ADDENDUM TO MC68306 Integrated EC000 Processor User's Manual

September 8, 1995

This addendum to the initial release of the MC68306UM/AD User's Manual provides corrections to the original text, plus additional information not included in the original. This document and other information on this product is maintained on the AESOP BBS, which can be reached at (800)843-3451 (from the US and Canada) or (512)891-3650. Configure the modem for up to 14.4K baud, 8 bits, 1 stop bit, and no parity. Terminal software should support VT100 emulation. Internet access is provided by telnetting to pirs.aus.sps.mot.com [129.38.233.1] or through the World Wide Web at <http://pirs.aus.sps.mot.com>.

Figure 8-1. Drive Levels and Test Points for AC Specifications

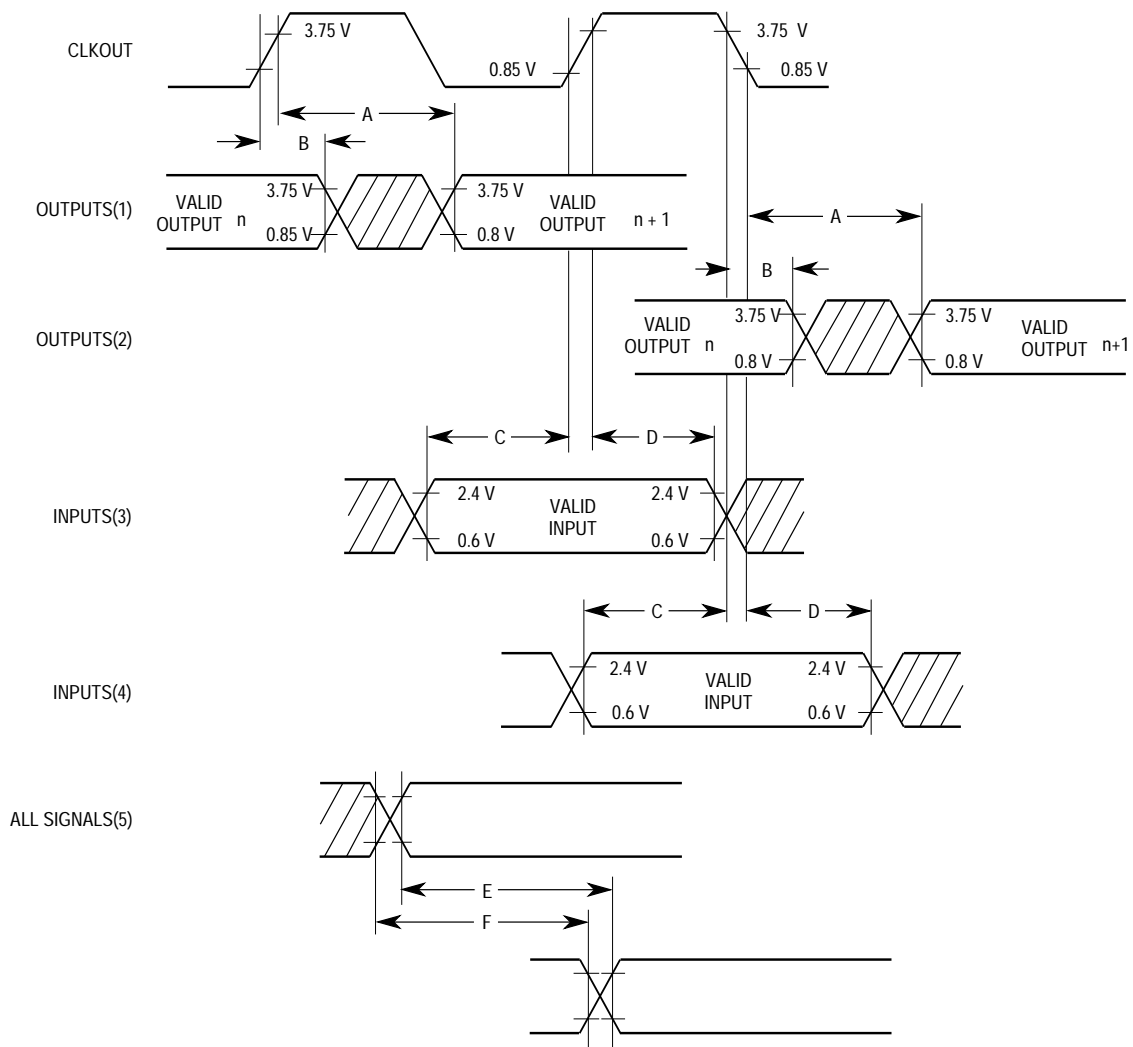
10. Drive Levels and Test Points for AC Specifications

The current drive levels and test points for the MC68306 are shown in the revised Figure 8-1 below (page 8-3).

Figure 8-5. Chip Select and Interrupt Acknowledge Timing Diagram

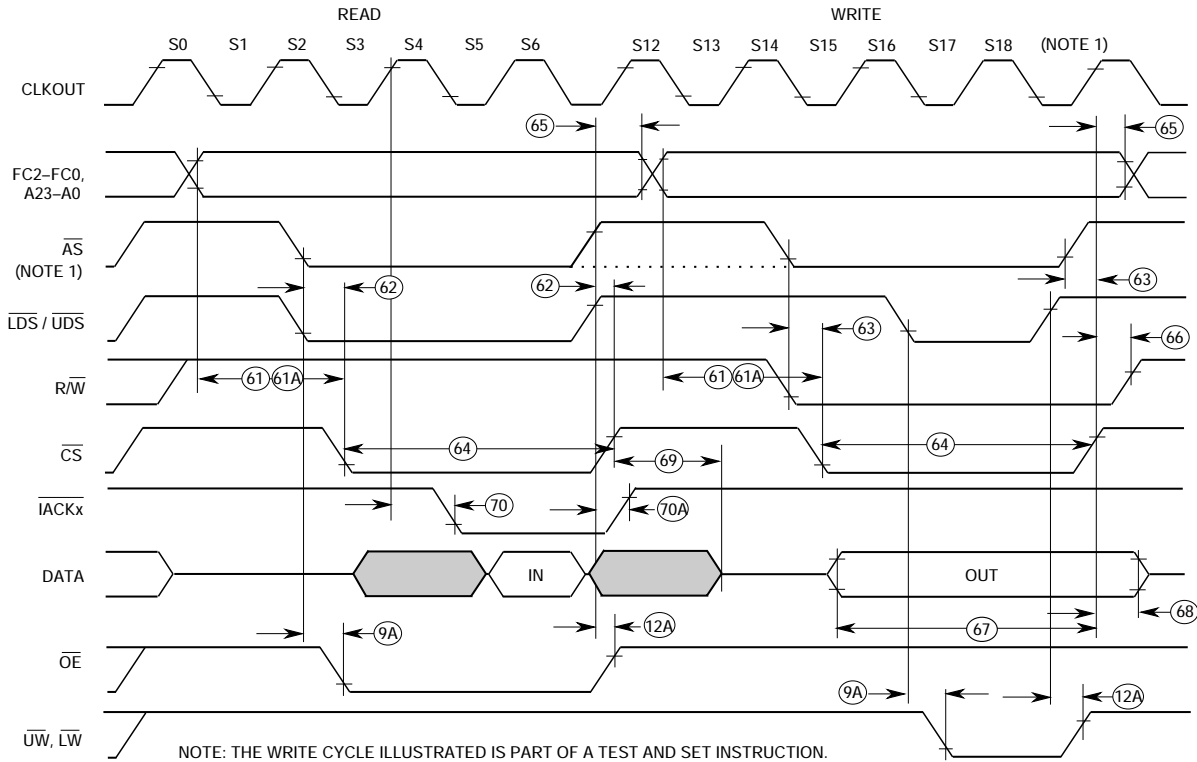
$\overline{\text{IACKx}}$ is shown asserted too early in Figure 8-5 on page 8-9. The figure below shows $\overline{\text{IACKx}}$ assertion time (spec 70) correctly referenced to the rising edge of state S4.

Figure 8-2. Clock Output Timing

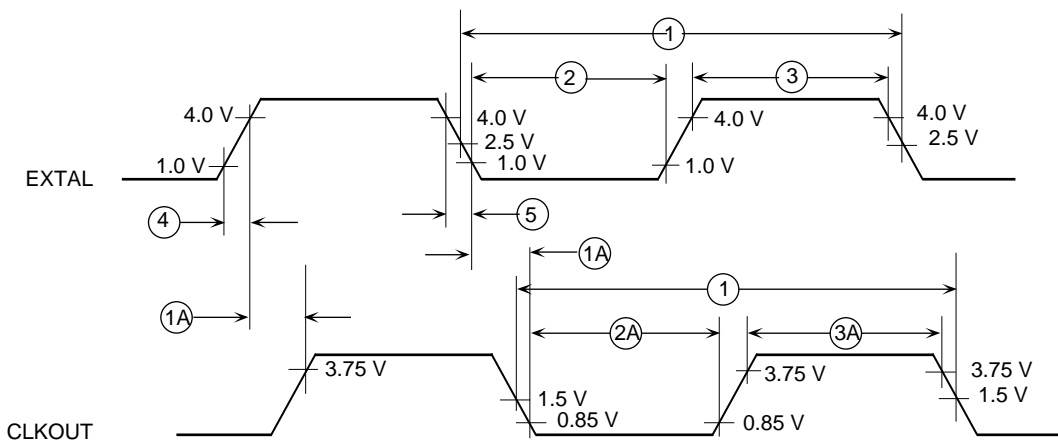
The current drive levels and test points for the MC68306 input and output clocks are shown in the revised Figure 8-2 below (see page 8-5.)

Figure 8-8. DRAM Timing – 0-Wait Read, No Refresh

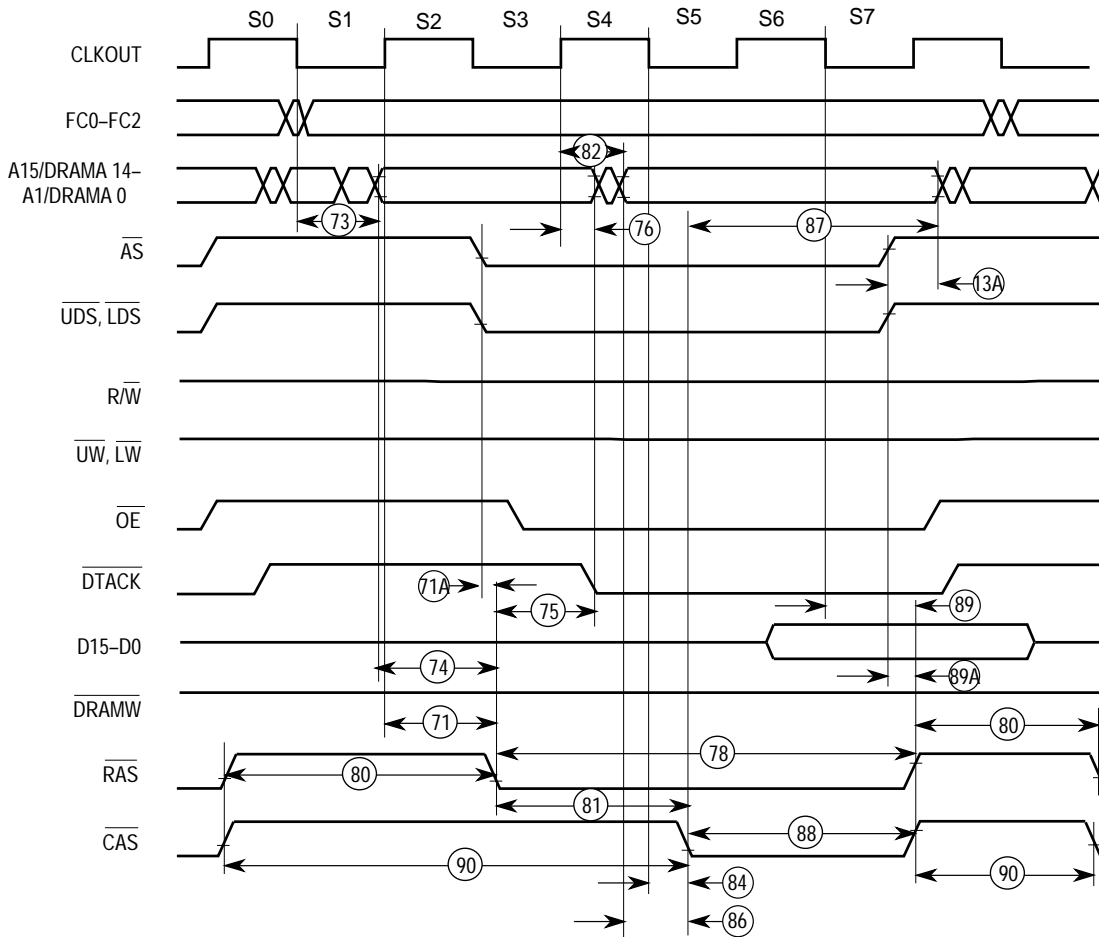
Specification 13A below has been added to the AC electrical specifications on page 8-5. A revised figure 8-8 from page 8-13 shows the new specification (address hold from AS/UDS/LDS negate near state S7).

Num	Characteristic	16.67 MHz		Unit
		Min	Max	
13A	AS, LDS, UDS Negated to Address Invalid, DRAM Cycle	0	—	ns

Figure 8-10. DRAM Timing Refresh

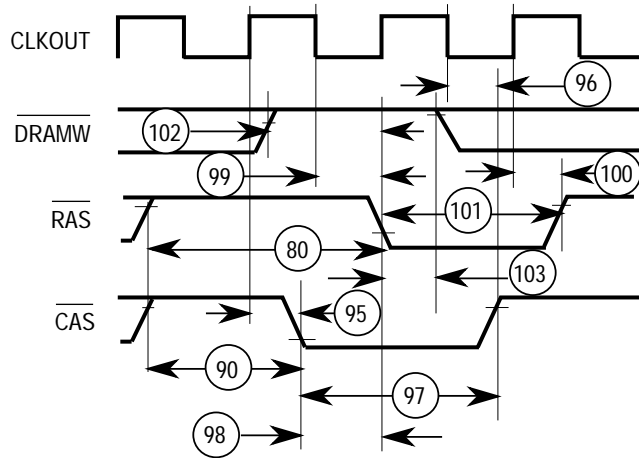
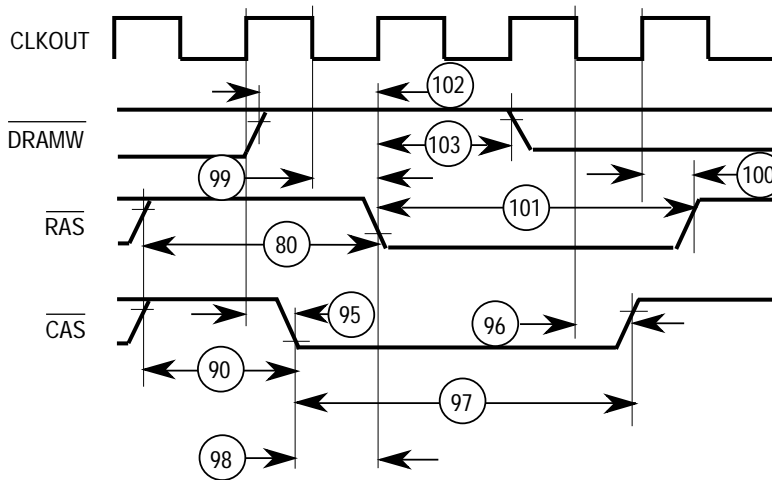
The specifications for DRAM refresh timing in the AC Specifications on page 8-12 and in Figure 8-10 on page 8-14 referenced the wrong clock edges. Corrected specifications and figures are shown below.

Num.	Characteristic	16.67 MHz				Unit
		0-Wait		1-Wait		
		Min	Max	Min	Max	
95	CLKOUT High to $\overline{\text{CASx}}$ Asserted (Refresh Cycle)	0	20	0	20	ns
96	CLKOUT Low to $\overline{\text{CASx}}$ Negated (Refresh Cycle)	0	20	0	20	ns
98	$\overline{\text{CASx}}$ Asserted to $\overline{\text{RASx}}$ Asserted (Refresh Cycle)	20	60	20	60	ns
99	CLKOUT Low to $\overline{\text{RASx}}$ Asserted (Refresh Cycle)	0	30	0	30	ns
100	CLKOUT High to $\overline{\text{RASx}}$ Negated (Refresh Cycle)	0	25	0	25	ns
102	$\overline{\text{DRAMW}}$ High to $\overline{\text{RASx}}$ Asserted (Refresh Cycle)	20	60	20	60	ns

Figure 8-9. DRAM Timing – 1-Wait Write, No Refresh

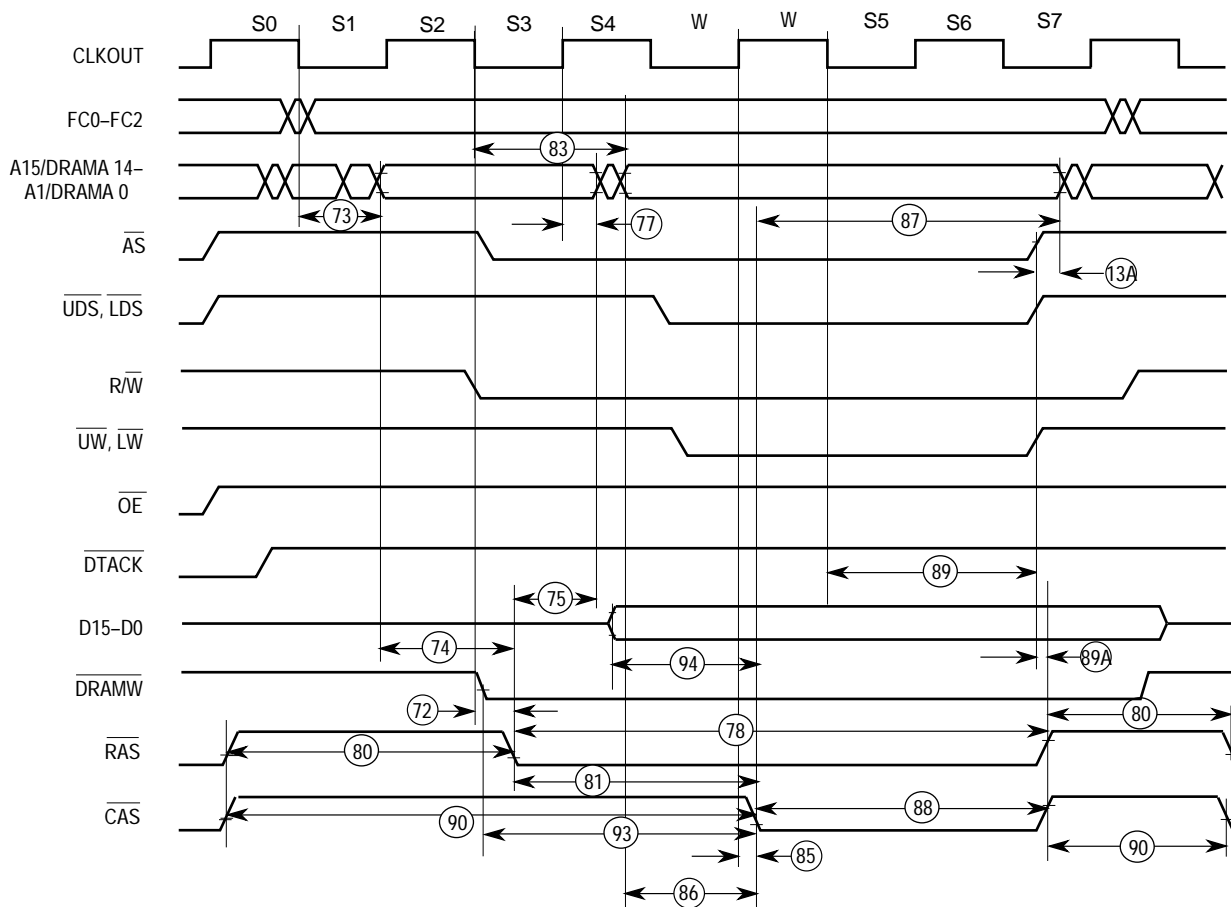
Figure 8-9 on page 8-14 is missing a wait state - see the revised figure below. Spec 13A has also been added to this figure.
